TELEVISION TECHNICAL BULLETIN

<u>MODELS</u>	56FW53H	66FW53H	76FW53H	66FW54H
	76FW54H	66GF63H	66GF64H	76GF64H

REASON Upgrade of defective opto-coupler .

Reference JR21052002-1

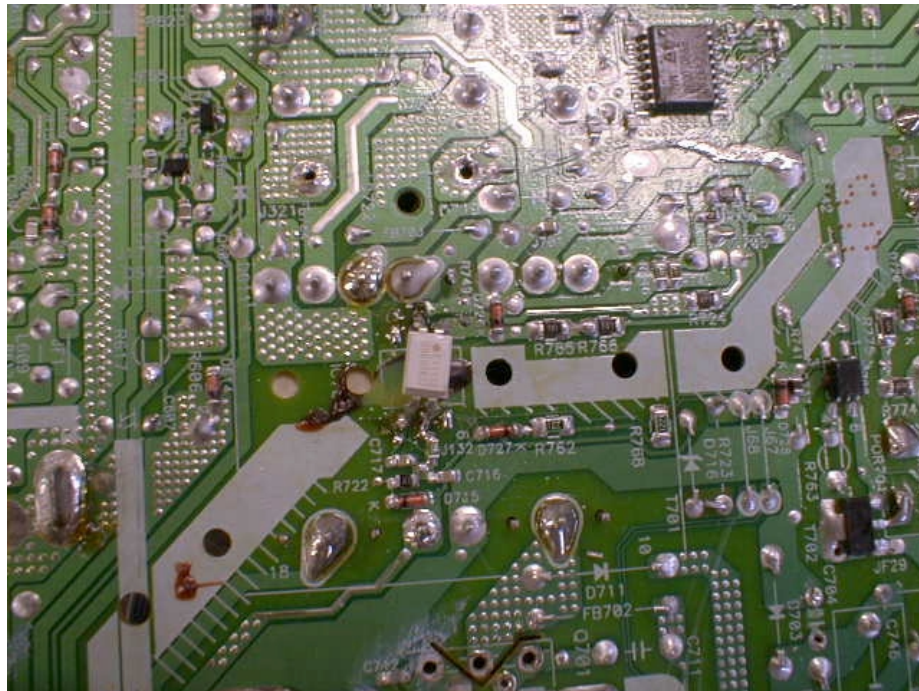
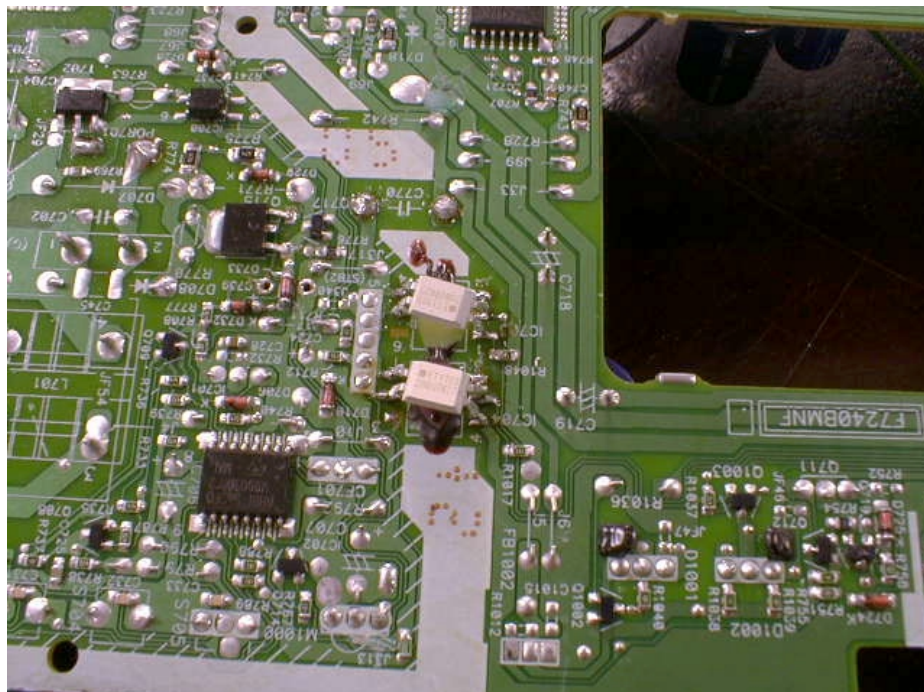
This 4 pin device replaces the 6 pin device.

Pins 1 and 2 are the same but pins 3 and 4 are the equivalent of pins 4 and 5.

This requires that the new opto-coupler is fitted Diagonally.

Please note the positioning of the opto couplers in the case of IC705 (power) above and the data opto couplers (IC703 and IC704)

ACTION Replace the following parts noting the different pinout of the optocoupler
